## CITY OF KELOWNA

# MEMORANDUM

**Date:** March 30, 2020  
**File No.:** DP20-0093  
**To:** Urban Planning Management (JB)  
**From:** Development Engineering Manager (JK)  
**Subject:** 401-407 Laurel Rd

# Development Permit DP20-0093

SITE PLAN / GROUND FLOOR PLAN  
SCALE: 1/8" = 1'-0"

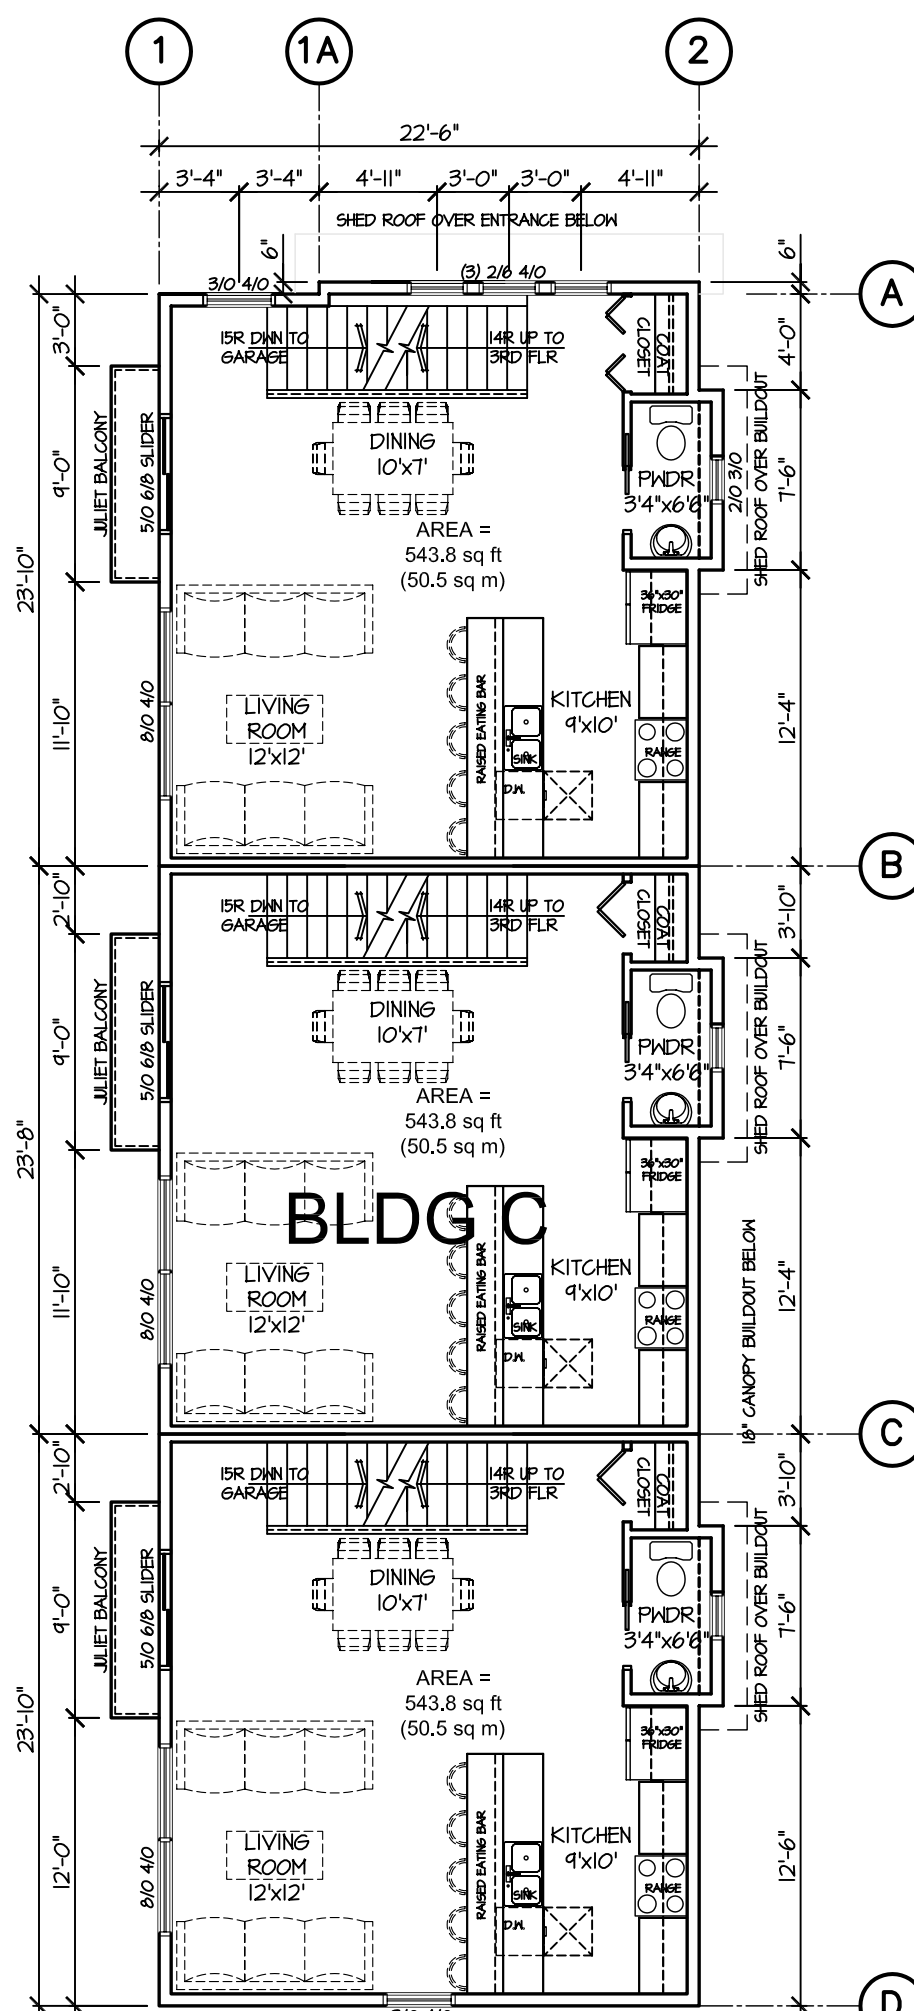
- a) As Laurel Rd is classified as a Major Collector, waste collection vehicles cannot back onto Laurel Rd. Please provide on-site turning movements showing an MSU vehicle turning on site without having to back onto Loseth Rd.
